**Subject:** Citizen Action Corrective Action Implementation Report Comments

The following comments are submitted to the New Mexico Environment Department for the **Sandia National Laboratories' Corrective Measures Implementation Report** (CMI Report) for the **Mixed Waste Landfill** that is a radioactive and hazardous waste dump contaminating Albuquerque's drinking water aquifer from its unlined pits and trenches.

**Figure 2. Schematic of the Monitoring Wells and the Hydrogeologic Setting at the Sandia MWL dump. The permeable sands and gravels in the Ancestral Rio Grande "A" Deposits (ARG deposits) are the valuable groundwater resource for Albuquerque and the surrounding region.**

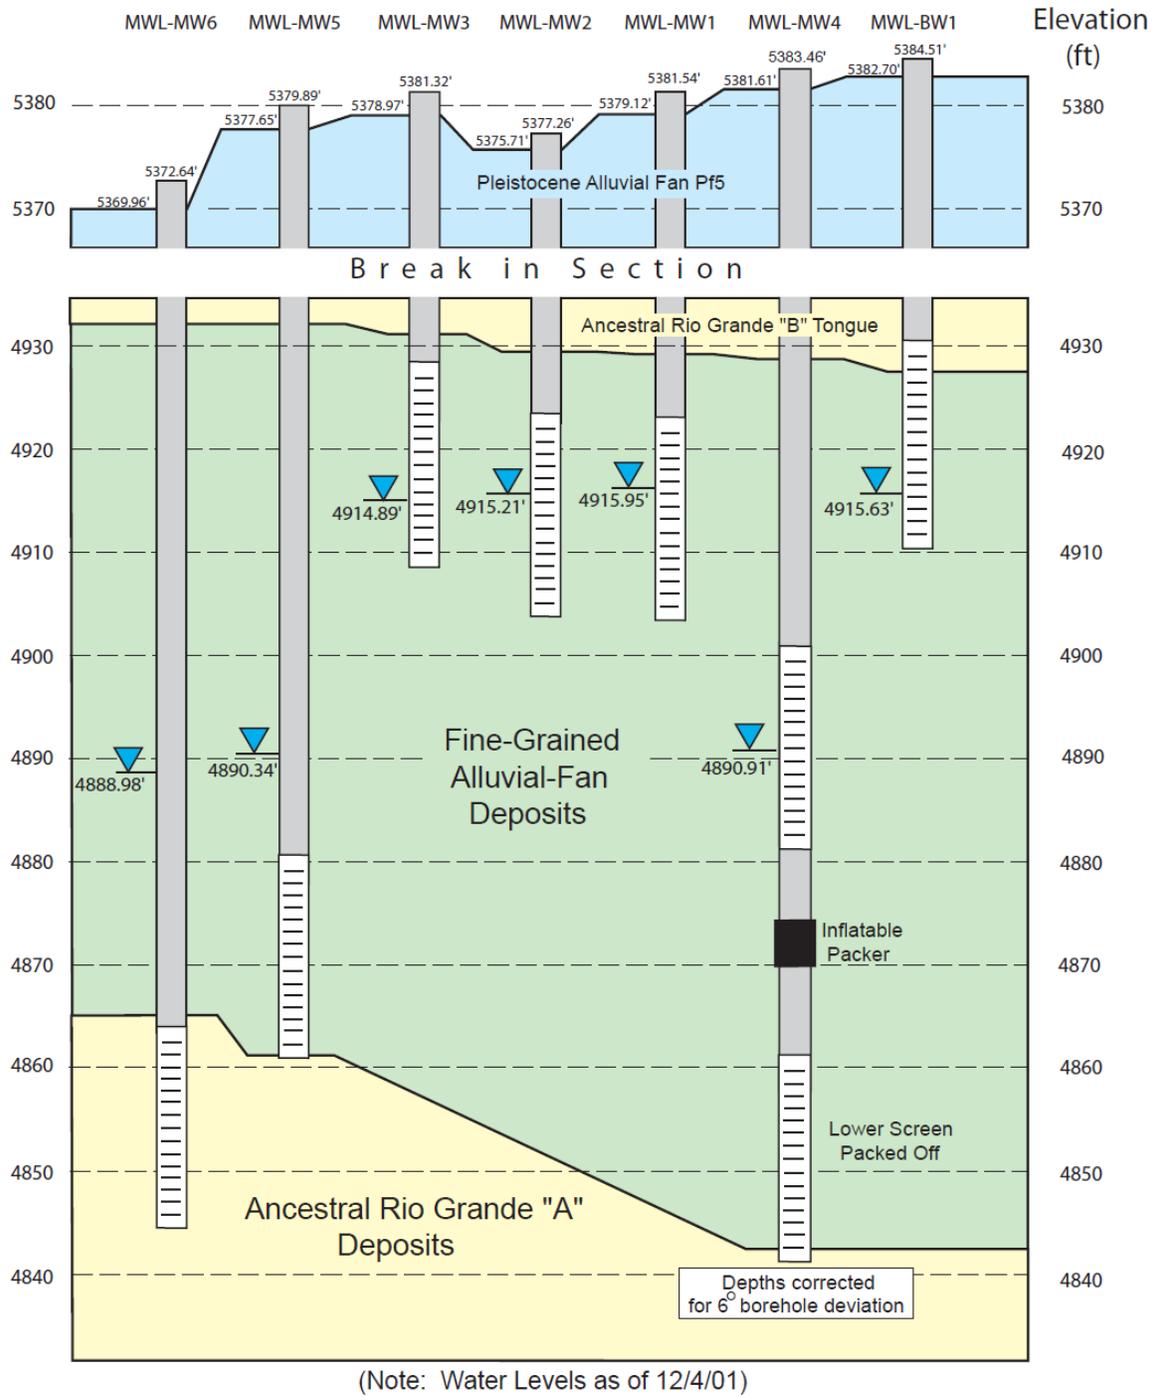
- There are two zones of saturation below the Sandia MWL dump that require networks of monitoring wells. A reliable network of monitoring wells was not installed in either of the two zones. Figure 2 (see attached) is a geologic cross section that shows

the two zones of saturation below the MWL dump that require networks of monitoring wells. The upper zone is the water table in the fine-grained alluvial fan sediments. The deeper zone is the Ancestral Rio Grande Deposits (ARG Deposits) that are below the layer of fine-grained alluvial fan sediments that form a leaky confining bed above the ARG Deposits.
